**PROJECT**  
90 COLLINS REDEVELOPMENT  
90 COLLINS STREET  
MELBOURNE VIC 3000

### PLANNING PERMIT APPLICATION

<b>Application number:</b>	<b>TP-2021-855</b>
<b>Applicant:</b>	Mirvac Victoria Pty Ltd
<b>Owner:</b>	Mirvac Capital Pty Ltd & 88 Collins Pty Ltd
<b>Architect:</b>	Fender Katsalidis
<b>Address:</b>	86-98 Collins Street, MELBOURNE VIC 3000
<b>Proposal:</b>	Partial demolition, external painting, multi-storey addition to the existing heritage building and reduction in bicycle facility requirements
<b>Cost of works:</b>	\$104,899,337
<b>Date of application:</b>	22 December 2021
<b>Responsible officer:</b>	Markus Tschech, Principal Urban Planner

**Figure 14 - Ground Level (left) and Level 2 (right) Demolition Plan extracts. From Drawings TP200 & TP202**

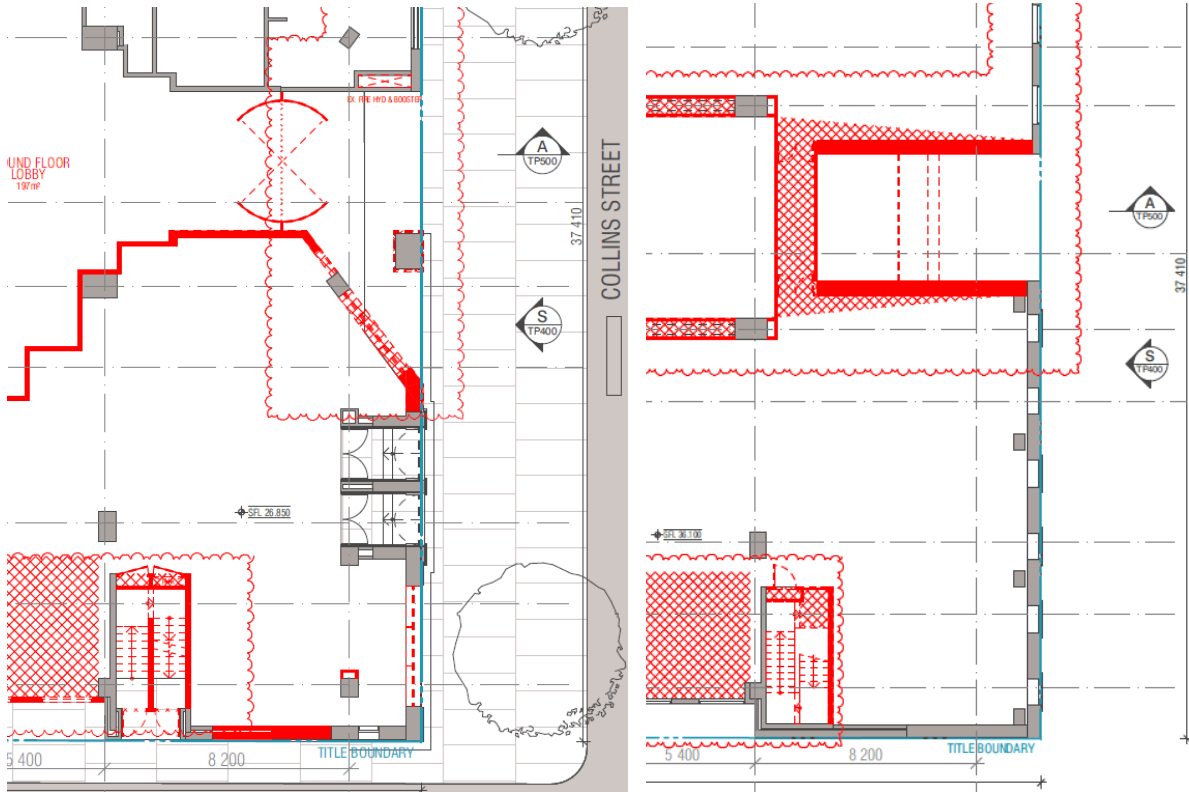
As no works are proposed to the building at 86-88 Collins Street, the key consideration in terms of demolition relates to the removal of original heritage fabric of the aforementioned three storey building on the corner of Collins Street and Alfred Place. The extent of demolition of this building is depicted in Figures 14 & 15 below.

- The proposed demolition is minor, and is related to shopfront windows and entries that have themselves been modified over time and are not entirely original.
- Demolition of the internal splay at the south-western corner of the building will allow the building line to be brought to the façade line, improving the development's streetscape response.
- The proposed demolition will allow for the continued use of the building into the future.

**Figure 18 - Tower floorplate extract from the submitted Urban Context Report**

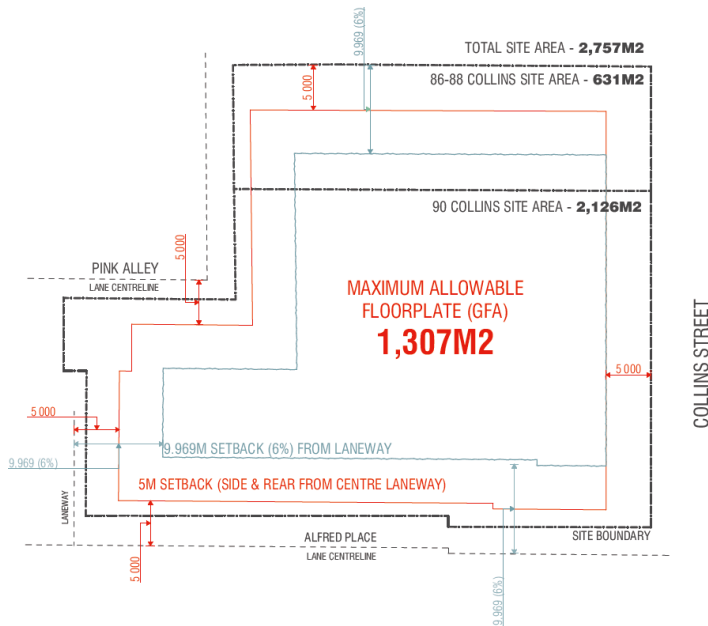
In terms of the tower floorplate, the permit applicant included the diagram at Figure 18 as part of the Urban Context Report, prepared by Fender Katsalidis, which indicates that the proposal has a maximum allowable floorplate of 1,307 m<sup>2</sup>. An analysis using the supplied PDFs indicates that this figure is correct.

With a proposed floorplate of 1,292 m<sup>2</sup>, and minimum setbacks of at least five metres to each boundary, the proposal complies with the *modified* (mandatory) tower floorplate requirements.

Figure 26 - Existing (left) and proposed (right) Wind Safety Conditions

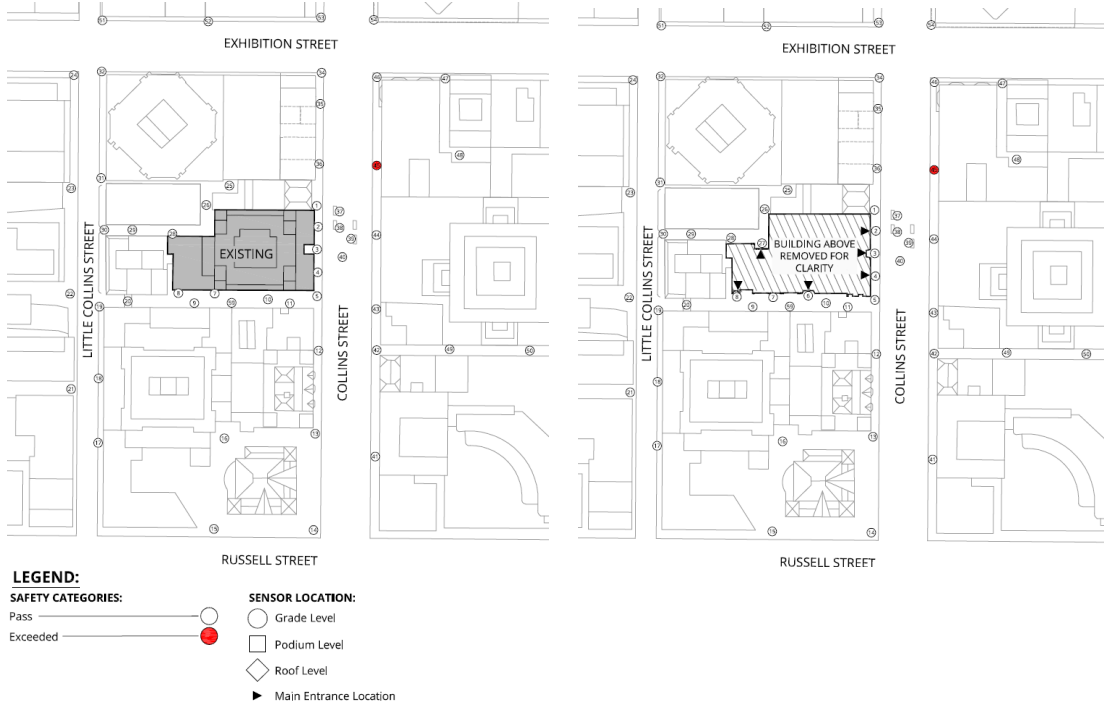
A revised Wind Tunnel Study, prepared by RWDI, dated 9 December 2021 adopts the criteria at Section 2.1 of DDO10 and includes an assessment of public areas within the applicable study area. As indicated in the extracts on the following page, the location of the addition above an existing high rise building would have a limited impact on existing wind conditions. To that end, it is noted that:

The proposed development therefore achieves the preferred wind conditions set out at Section 2.3 of DDO10, as well as the mandatory requirements. Importantly, the report does not recommend any design changes to achieve this result.

Figure 29 - 11am Shadow Diagram on Equinox (left) and Winter Solstice (right) showing no additional overshadowing of nearby public plazas

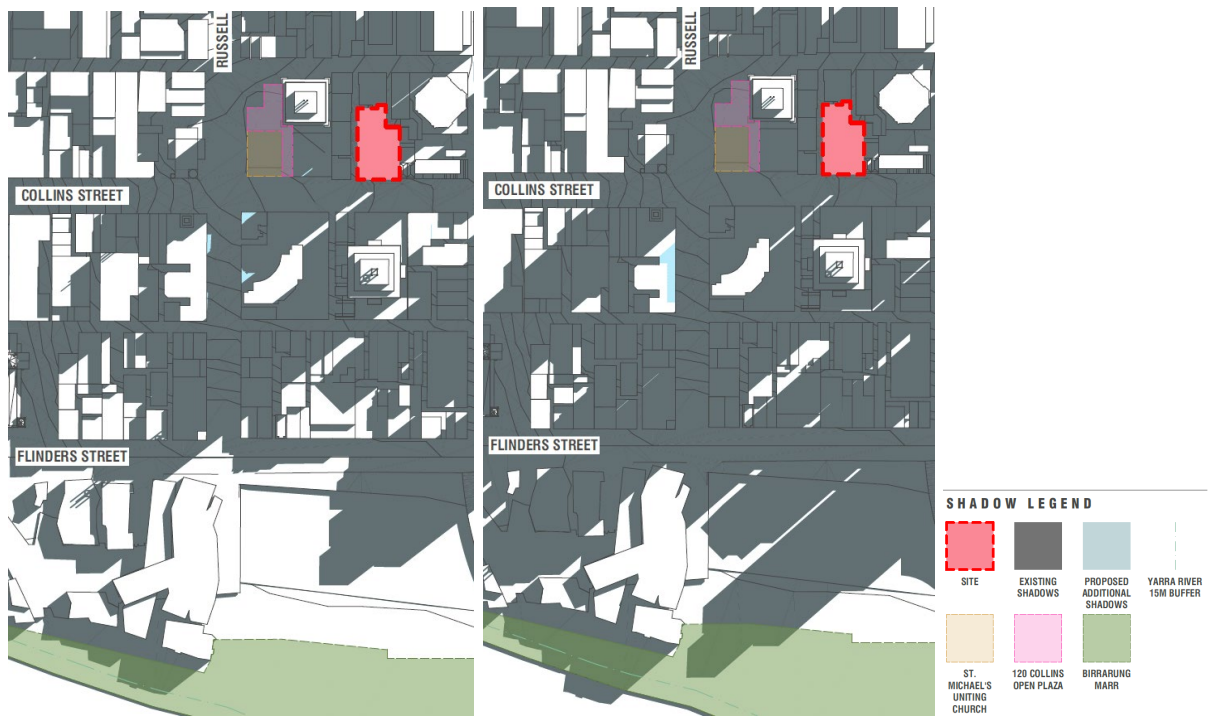
Tables 1 and 2 to DDO10 list key locations that must not be affected by additional shadows at certain times of the day and year. The proposed shadow diagrams submitted with the application demonstrate that no new shadow would be cast over the locations listed in the specified tables.

Figure 34 - Section A extract highlighting the excluded area on Level 23. From Drawing TP500

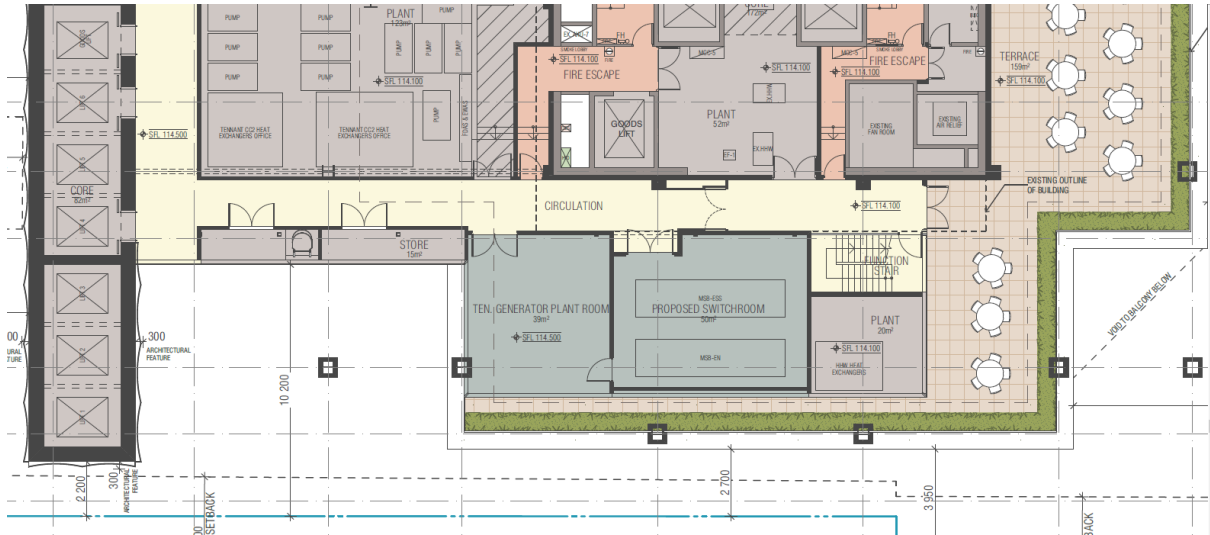
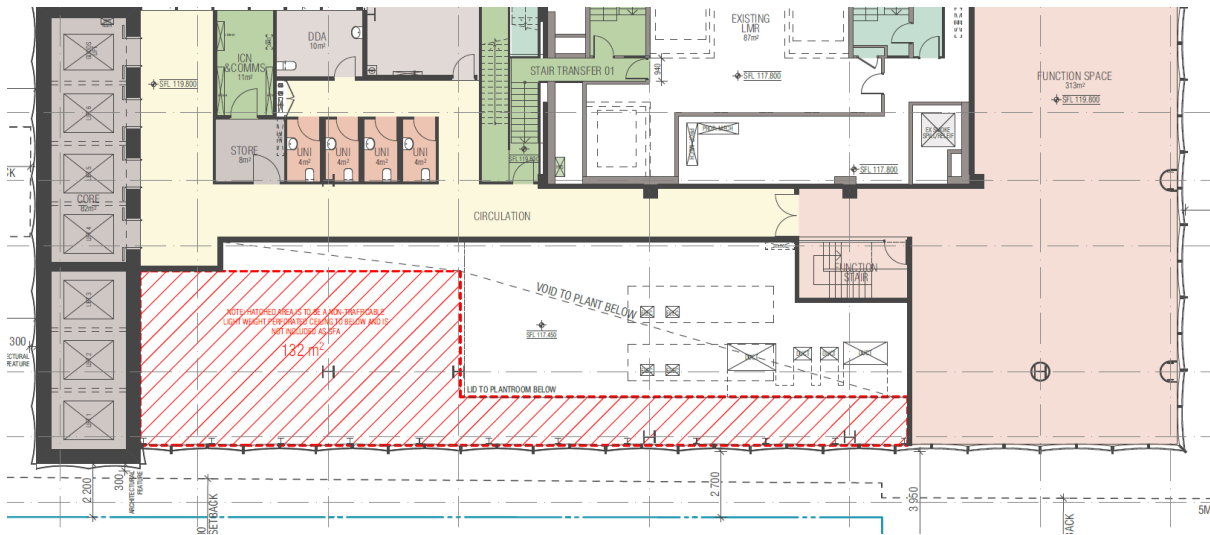
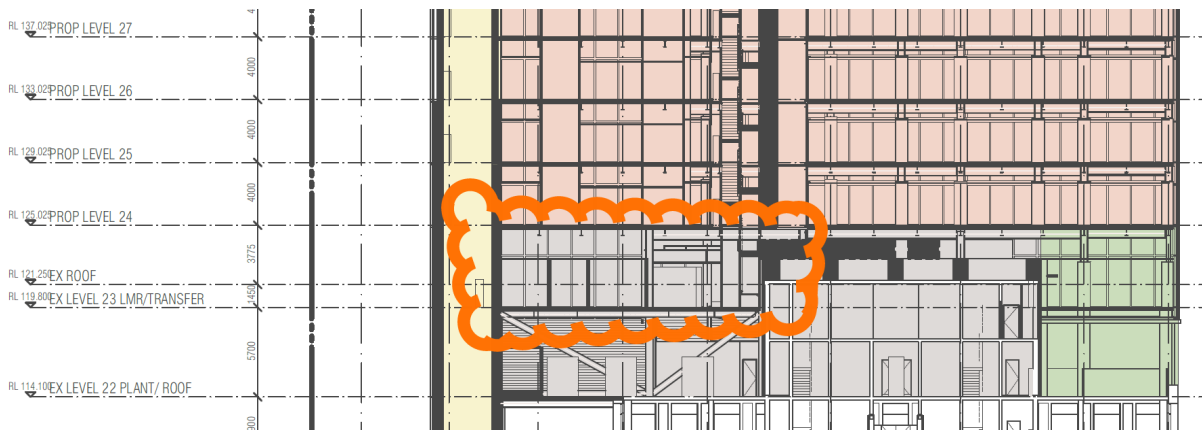
One of the objectors submitted that the Gross Floor Area for the purpose of calculating Floor Area Ratio (FAR) incorrectly exclude 132 m<sup>2</sup> of floorspace on level 23. An extract from the proposed Level 22 and 23 plan and relevant section highlighting the excluded section is provided below.

The floor plan for Level 23 describes the excluded area as a 'non-trafficable lightweight perforated ceiling' which appears to have been included for architectural purposes to match the adjacent plant room and create a more regular soffit. The space is only partially enclosed, and serves as an architectural feature that does not form part of a service element.

For that reason, it is considered correct to exclude the space from Gross Floor Area calculations.
